Road Safety Audit Report

Proposed Extension of Wychwood Green Crawley Down

Technical Note: RSA GG119 Response – Wychwood Place Extension

Technical Note: RSA GG119 Response – Wychwood Place Intensification

Item Location Plan

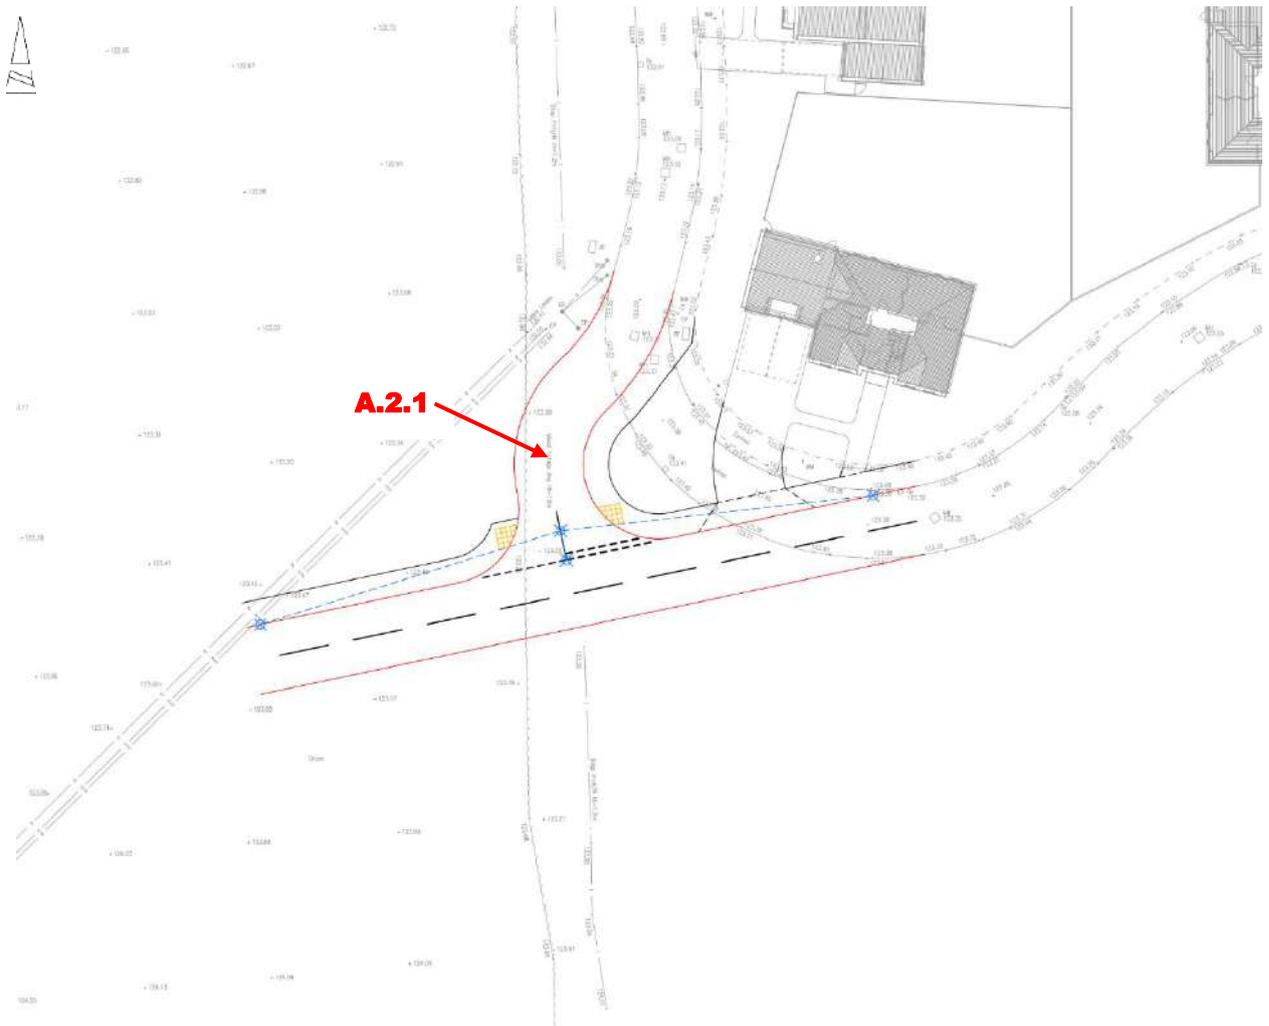
A.1	LOCAL ALIGNMENT
	<i>No Road Safety Concerns regarding LOCAL ALIGNMENT have been raised at this stage.</i>
A.2	GENERAL
A.2.1	PROBLEM
Location:	Woods View
Summary:	Realigned carriageway may not allow for the large vehicles
Acc Type:	Sideswipe type collisions
<p>The 5.5 metre wide Wychwood Place continues as Wychwood Green before continuing as Woods View following a bend in the road before the carriageway narrows to 5.0 metres. The proposals include an extension of the 5.5 metre section of Wychwood Green which is to continue into the application site. The section of Woods View that currently follows a bend in the road is to be marginally realigned and widened to 5.5 metres around a circa 9 metre road centreline radius on approach to a simple priority junction with the extension. Whilst the extension of the 5.5 metre carriageway should be adequate to accommodate the expected vehicles, the Audit Team have concerns that the realigned Woods View will not allow for large vehicles to include refuse / recycling collection vehicles. A carriageway that is inadequate for the expected vehicles, could result in the need for a large vehicle to encroach the adjacent footway / verge and could lead to loss of control or sideswipe type collisions.</p>

RECOMMENDATION:	
It is recommended that the realigned carriageway allows for the expected vehicles.	
Location Plan:

RSA Problem	RSA Recommendation	Design Organisation Response	Overseeing Organisation Response	Agreed RSA Action
<p>A.2.1 The 5.5 metre wide Wychwood Place continues as Wychwood Green before continuing as Woods View and following a bend in the road where the carriageway narrows to 5.0 metres. The proposals include an extension of the 5.5 metre section of Wychwood Green which is to continue into the application site. The section of Woods View that currently follows a bend in the road is to be marginally realigned and widened to 5.5 metres around a circa 9 metre road centreline radius on approach to a simple priority junction with the extension. Whilst the extension of the 5.5 metre carriageway should be adequate to accommodate the expected vehicles, the Audit Team have concerns that the realigned Woods View will not allow for the vehicles that can be expected to include refuse / recycling collection vehicles. A carriageway that is inadequate for the expected vehicles, could result in the need for a large vehicle to encroach the adjacent footway / verge and could lead to loss of control or sideswipe type collisions.</p>	<p>It is recommended that the realigned carriageway allows for the expected vehicles.</p>	<p>Agreed. Minor widening has been undertaken. Vehicle tracking for a refuse collection vehicle has been undertaken and shown as an inset in drawing ITB9155-GA-048C and demonstrates that there is adequate space along the realigned carriageway for the expected vehicles. Such vehicles will be occasional and are expected to be the largest vehicle that would make the manoeuvre.</p>

Location Plan:

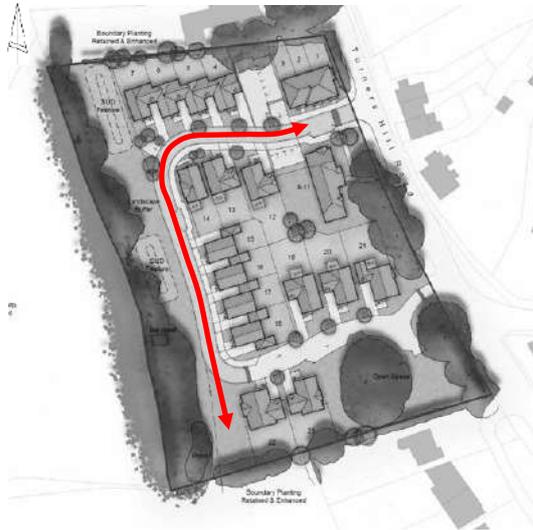
RECOMMENDATION:	
It is recommended that measures are provided to deter traffic utilising Woods View.	
Location Plan:	
A.2.4	PROBLEM
Location:	Wychwood Place
Summary:	Pedestrians within the shared surface carriageway may not be clearly visible
Acc Type:	Vehicle to pedestrian type collisions
<p>Wychwood Place is shared surface in the vicinity of its junction with Turners Hill Road before transitioning to a general carriageway with footways. The length of Wychwood Place benefits from street lighting, however, it is anticipated that the level of illuminance is low due to the low-level</p>

lighting bollards that are present throughout the development. The proposals include an extension of Wychwood Place to serve an additional 150 homes. The Assessment Team have concerns that an inadequate level of lighting is provided along the shared surface section of Wychwood Place. Vehicles are generally driven during the hours of darkness with headlights illuminated, however, a low level of lighting within a shared surface area may result in a motorist not becoming aware of a pedestrian within the carriageway and lead to vehicle to pedestrian type collisions.

It is recommended that an adequate level of street lighting is provided.

RSA Problem	RSA Recommendation	Design Organisation Response	Overseeing Organisation Response	Agreed RSA Action
<p>A.2.4 Wychwood Place is shared surface in proximity of its junction with Turners Hill Road before transitioning to a general carriageway with footways. The length of Wychwood Place benefits from street lighting, however, it is anticipated that the level of illuminance is low due to the low-level lighting bollards that are present throughout the development. The proposals include an extension of Wychwood Place to serve an additional 150 homes. The Assessment Team have concerns that an inadequate level of lighting is provided along the shared surface section of Wychwood Place. Vehicles are generally driven during the hours of darkness with headlights illuminated, however, a low level of lighting within a shared surface area may result in a motorist not becoming aware of a pedestrian within the carriageway and lead to vehicle to pedestrian type collisions.</p>	<p>It is recommended that an adequate level of street lighting is provided.</p>	<p>The mater will be addressed at the detailed design stage. However, it is important to note that the street presently operates safely and will continue to operate at a level of traffic flow that is suitable for shared surface operation. That said, residents are able to either exit the site via alternative routes or walk along the verge.</p>

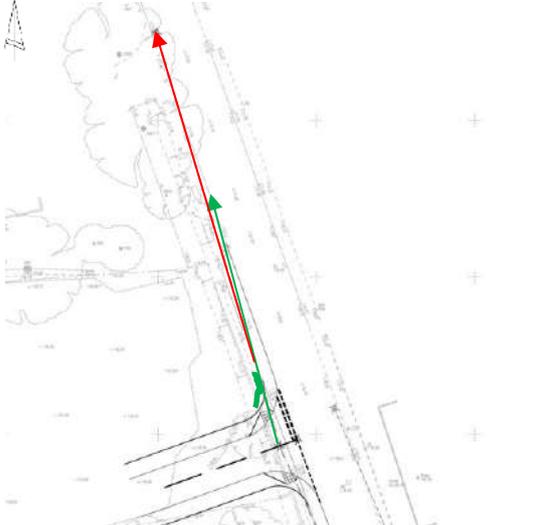
A.3	JUNCTIONS
A.3.1	PROBLEM
Location:	Wychwood Place
Summary:	Boundary hedge limits visibility to the north at the existing priority junction
Acc Type:	Vehicle rear / side impact type collisions
<p>Wychwood Place meets Turners Hill Road at a simple priority junction. The proposals include an extension of Wychwood Place to serve an additional 150 homes. The approved plan (ITB9155-GA-001D) associated with Phase 1 of Wychwood Place, identifies that visibility splays of 2.4x57.4 metres are achievable from the priority junction which is understood to accord with observed 85th percentile approach speeds. It is noted, however, that a boundary hedge to the north limits the level of visibility. The Assessment Team have concerns that inadequate visibility at a priority access could result in a motorist or cyclist attempting to undertake a manoeuvre when it is not safe to do so, leading to rear or side impact type collisions.</p>

RECOMMENDATION:	
It is recommended that an adequate level of visibility is achievable at all times.

RSA Problem	RSA Recommendation	Design Organisation Response	Overseeing Organisation Response	Agreed RSA Action
<p>A.3.1 Wychwood Place meets Turners Hill Road at a simple priority junction. The proposals include an extension of Wychwood Place to serve an additional 150 homes. The approved plan (ITB9155-GA-001D) associated with Phase 1 of Wychwood Place, identifies that visibility splays of 2.4x57.4 metres are achievable from the priority junction which is understood to accord with 85th percentile approach speeds. It is noted, however, that a boundary hedge to the north limits the level of visibility. The Assessment Team have concerns that inadequate visibility at a priority access could result in a motorist or cyclist attempting to undertake a manoeuvre when it is not safe to do so and rear of side impact type collisions.</p>	<p>It is recommended that an adequate level of visibility is achievable at all times.</p>	<p>Accepted – as shown on Drawing ITB9155-GA-064, at the rear of this note adequate visibility splays of 2.4m x 59m can be achieved in both directions, and hedgerow within the visibility splays will be cut back and maintained.</p>

Item Location Plan

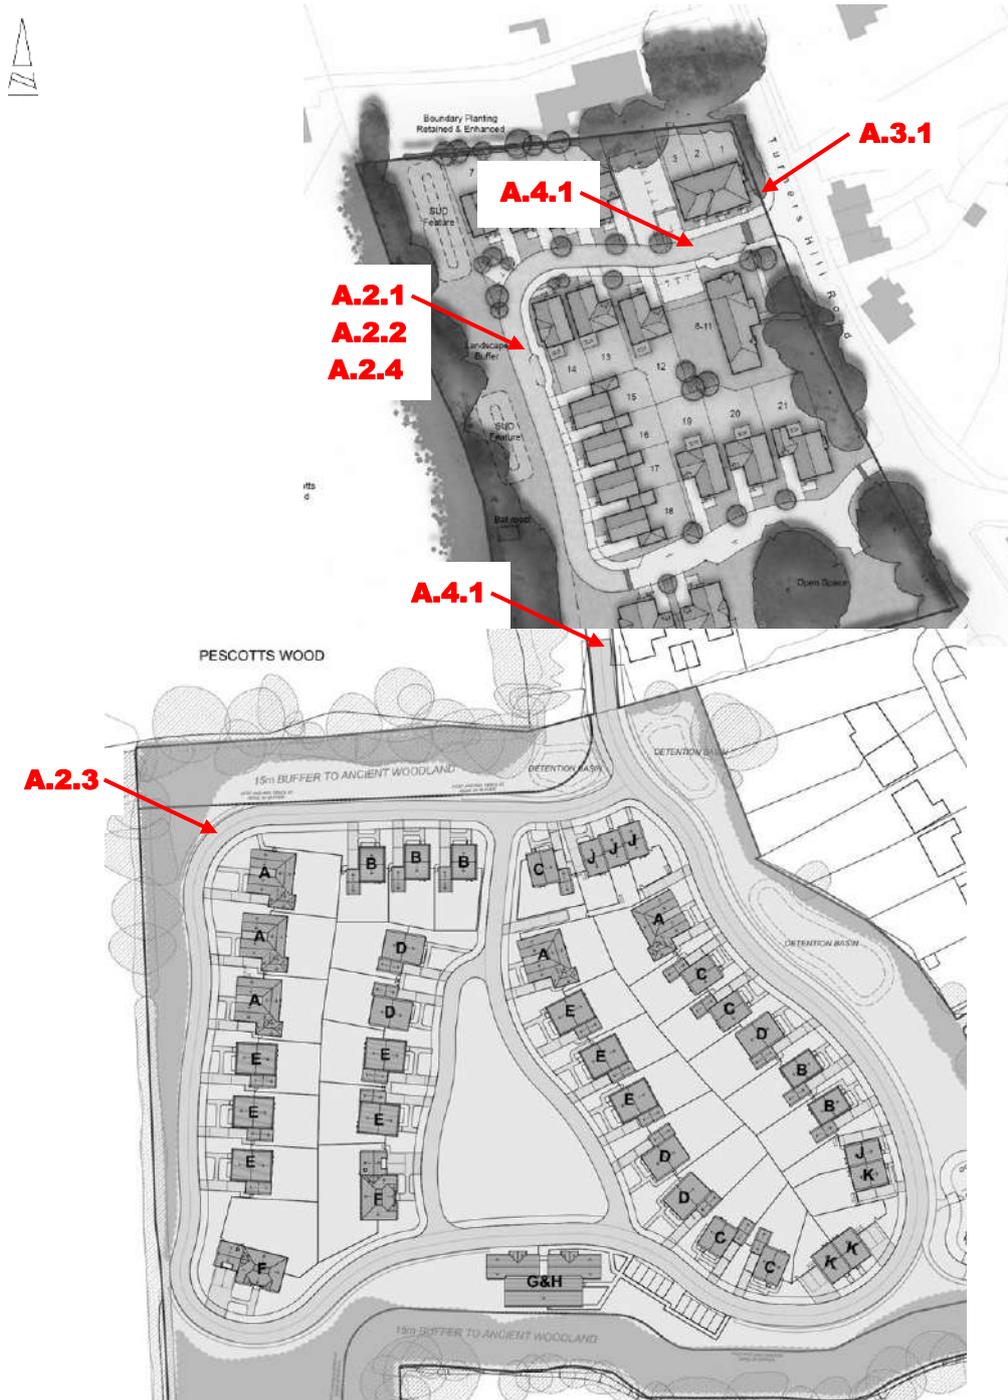
A.1	LOCAL ALIGNMENT
	<i>No Road Safety Concerns regarding LOCAL ALIGNMENT have been raised at this stage.</i>
A.2	GENERAL
A.2.1	PROBLEM
Location:	Wychwood Place
Summary:	Existing 5.5 metre wide shared surface may not allow adequate capacity
Acc Type:	Sideswipe and vehicle to pedestrian type collisions
<p>Wychwood Place is a cul-de-sac that served Phase 1 of a development that consists of 23 homes before being extended to serve Phase 2 with an additional 44 homes and observes a two-way traffic flow of circa 26 vehicular movements during each peak hours. The section of Wychwood Place within Phase 1 takes the form of a 5.5 metre wide shared surface carriageway that benefits from a circa 2 metre grass margin along one side and follows a 90° bend. That carriageway continues into Phase 2 where a footway is provided both sides of the carriageway which follows a number of bends. The proposals include the intensification of Wychwood Place to serve an additional 150 homes which is expected to generate 105 vehicular movements during the morning peak hour and 103 during the afternoon peak hour. No junction modelling has been provided to identify that the simple priority junction of Wychwood Place with Turners Hill Road, however, the flows are not considerable and therefore it is clear that the junction will operate within capacity. The section of Wychwood Place within Phase 2, which consists of a general carriageway with footways, should be adequate to accommodate the additional traffic that is expected to be generated by 150 homes, however, the Assessment Team have concerns that the existing 5.5 metre wide shared surface section are not appropriate for the expected demand, particularly when taking account of the 90° bend. It is noted that the 2.0 metre grass margin should allow for pedestrians to step off the carriageway to seek refuge, nevertheless, a shared surface carriageway that is inadequate for the expected flows could lead to sideswipe and vehicle to pedestrian type collisions. The Assessment Team note that based on the Site Layout plans included on the Planning Portal of Mid-Sussex District Council, the existing grass margin within Phase 1 should be a footway.</p>

RECOMMENDATION:	
It is recommended that the existing margin is upgraded to a footway.

<p>Location Plan:</p>	
A.2.2	PROBLEM
Location:	Wychwood Place
Summary:	No measures are provided to highlight the shared nature of the carriageway through Phase 1
Acc Type:	Vehicle to pedestrian type collisions
<p>The shared surface carriageway that was provided as part of Phase 1 of Wychwood Place appears to have been constructed with a general carriageway surface, albeit slightly lighter than the adjacent carriageways that benefit from footways. The proposals include an intensification in use of Wychwood Place to serve an additional 150 homes which is expected to add up to 105 vehicular movements to the route. Whilst existing, the Assessment Team have concerns that the shared surface carriageway appears the same as the adjacent general carriageway and as such, no warning is provided to motorists to highlight the change in route characteristics. Motorists not becoming aware of a transition from a carriageway to a shared surface, could continue unaware of the potential for pedestrians to be within the carriageway which could lead to vehicle to pedestrian type collisions.</p>

RECOMMENDATION:	
It is recommended that measures are provided to highlight the change in route characteristics.	
<p>Location Plan:</p>

A.2.3	PROBLEM
Location:	Woods View
Summary:	Traffic may not proceed along the intended route
Acc Type:	Vehicle sideswipe type collisions
<p>Wychwood Place is 5.5 metres wide and benefit from a footway both sides of the carriageway with the southern footway terminating following a block of apartments where the carriageway continues as Wychwood Green. Wood View is a side road that is 5.0 metres wide and benefits from a footway along one side of the carriageway. No Road markings are provided within the existing development. The proposals include a continuation of Wychwood Green to serve a development of 150 homes. It is understood that the intended primary route for traffic accessing the proposed development is along Wychwood Place, however, a route assessment has determined that access via Woods View is shorter and more convenient than following Wychwood Place. Motorists are therefore highly likely to travel along the narrower Woods View. Whilst Woods View is 5.0 metres wide and adequate to accommodate two-way traffic, the carriageway follows two straightish carriageways that do not benefit from traffic calming, which could lead to inappropriate speeds within the existing development and sideswipe type collisions.</p>

<p>Location Plan:</p>  	
A.4	WALKING, CYCLING AND HORSE RIDING
A.4.1	PROBLEM
Location:	Wychwood Place
Summary:	No measures are provided to allow pedestrian access between the existing footways and shared surface carriageway
Acc Type:	Vehicle to pedestrian type collisions
<p>Phase 1 of Wychwood Place is taken off Turners Hill Road and allows access to Phase 2 of Wychwood Place. The initial carriageway takes the form of a shared surface that transitions to a general carriageway that benefits from footways. It is noted that no level access is provided for pedestrians to gain access between the existing footway either side of the shared surface area. The proposals include an extension of Wychwood Place to serve an additional 150 homes. The Assessment Team have concerns that whilst existing, the full height kerb between the shared surface area and footways, are a trip hazard which could lead to falls and personal injuries. Furthermore, no tactile warning is provided to highlight the change in route characteristics to pedestrians.</p>

RECOMMENDATION:	
It is recommended that dropped kerbs and tactile warning is provided to allow pedestrian access to the shared surface carriageway.

RSA Problem	RSA Recommendation	Design Organisation Response	Overseeing Organisation Response	Agreed RSA Action
<p>A.2.1 The section of Wychwood Place within Phase 2, which consists of a general carriageway with footways, should be adequate to accommodate the additional traffic that is expected to be generated by 150 homes, however, the Assessment Team have concerns that the existing 5.5-metre-wide shared surface section are not appropriate for the expected demand, particularly when taking into account the 90° bend. It is noted that the 2.0 metre grass margin should allow for pedestrians to step off the carriageway to seek refuge, nevertheless, a shared surface carriageway that is inadequate for the expected flows could lead to sideswipe and vehicle to pedestrian type collisions. The Assessment Team note that based on the Site Layout plans included on the planning portal of Mid Sussex District Council, the existing grass margin within Phase 1 should be a footway.</p>	<p>It is recommended that the existing margin is upgraded to a footway.</p>	<p>There are two alternative points of access - one allowing pedestrians to walk to Huntsland and one allowing pedestrians and cyclists to access Turners Hill Road adjacent to the signal-controlled crossing there. As part of the sustainable transport strategy for the site, a northward extension of the footway on Wychwood Place is proposed, as far as the shared surface that provides a connection to the pedestrian / cycle access (<i>ref: ITB9155-GA-056A in the Transport Assessment</i>). Whilst traffic flows are expected to remain under the 100vph at which MfS identifies that shared surfaces work best, it will be possible for new residents to avoid the section that has a shared surface. Residents living along the section will be able to walk in carriageway or use the verge adjacent to it if they prefer.</p>

RSA Problem	RSA Recommendation	Design Organisation Response	Overseeing Organisation Response	Agreed RSA Action
<p>A.2.2 The shared surface carriageway that was provided as part of Phase 1 of Wychwood Place appears to have been constructed with a general carriageway surface, albeit slightly lighter than the adjacent carriageways that benefit from footways. The proposals include an extension of Wychwood Green to serve an additional 150 homes that is expected to intensify the use of the existing shared surface carriageway. Whilst existing, the Assessment Team have concerns that the shared surface carriageway appears the same as the adjacent general carriageway and as such, no warning is provided to motorists to highlight the change in route characteristics. Motorists not becoming aware of a transition from a carriageway to a shared surface, could continue unaware of the potential for pedestrians to be within the carriageway which could lead to vehicle to pedestrian type collisions.</p>	<p>It is recommended that measures are provided to highlight the change in route characteristics.</p>	<p>Accepted – Drawing ITB9155-GA-064 at the rear of this note presents rumble strips to denote a share surface, as well as dropped kerbs provided (where not already available) to allow pedestrians to join shared surface / footway.</p>

RSA Problem	RSA Recommendation	Design Organisation Response	Overseeing Organisation Response	Agreed RSA Action
<p>A.2.3 Wychwood Place as well as the continuation at Wychwood Green are both 5.5 metres wide and benefit from a footway both sides of the carriageway with the southern footway terminating following a block of apartments. Wood View is a side road that is 5.0 metres wide and benefits from a footway along one side of the carriageway. No Road markings are provided within the existing development. The proposals include an extension of Wychwood Green to serve a development of 150 homes. It is understood that the intended primary route for traffic accessing the proposed development is along Wychwood Place, however, a route assessment has determined that access via Woods View is shorter and more convenient than following Wychwood Place. Motorists are therefore highly likely to travel along the narrower Woods View. Whilst Woods View is 5.0 metres wide and adequate to accommodate two-way traffic, the carriageway follows two straightish carriageways that do not benefit from traffic calming which could lead to inappropriate speeds within the existing development and sideswipe type collisions.</p>	<p>It is recommended that measures are provided to deter traffic utilising Woods View.</p>	<p>Continuing south on Wychwood Place will allow traffic to avoid turning right at the eastern end of Woods View. Continuing on Wychwood Place is therefore likely to be more convenient for most and it is expected that traffic will therefore do so. Traffic flow on Woods View is unlikely to materially change. However, the new access junction at the south west of Woods View (subject to a separate audit) will feature give way lines, making Woods View the minor arm.</p>

RSA Problem	RSA Recommendation	Design Organisation Response	Overseeing Organisation Response	Agreed RSA Action
<p>A.4.1 Phase 1 of Wychwood Place is taken off Turners Hill Road and allows access to Phase 2 of Wychwood Place. The initial carriageway takes the form of a shared surface that transitions to a generally carriageway that benefits from footways. It is noted that no level access is provided for pedestrians to gain access between the existing footway either side of the shared surface area. The proposals include an extension of Wychwood Place to serve an additional 150 homes. The Assessment Team have concerns that whilst existing, the full height kerb between the shared surface area and footways, are a trip hazard which could lead to falls and personal injuries. Furthermore, no tactile warning is provided to highlight the change in route characteristics to pedestrians</p>	<p>It is recommended that dropped kerbs and tactile warning is provided to allow pedestrian access to the shared surface carriageway.</p>	<p>Accepted – Drawing ITB9155-GA-064 shows that dropped kerbs will be provided (where not already available) to allow pedestrians to join shared surface / footway.</p>
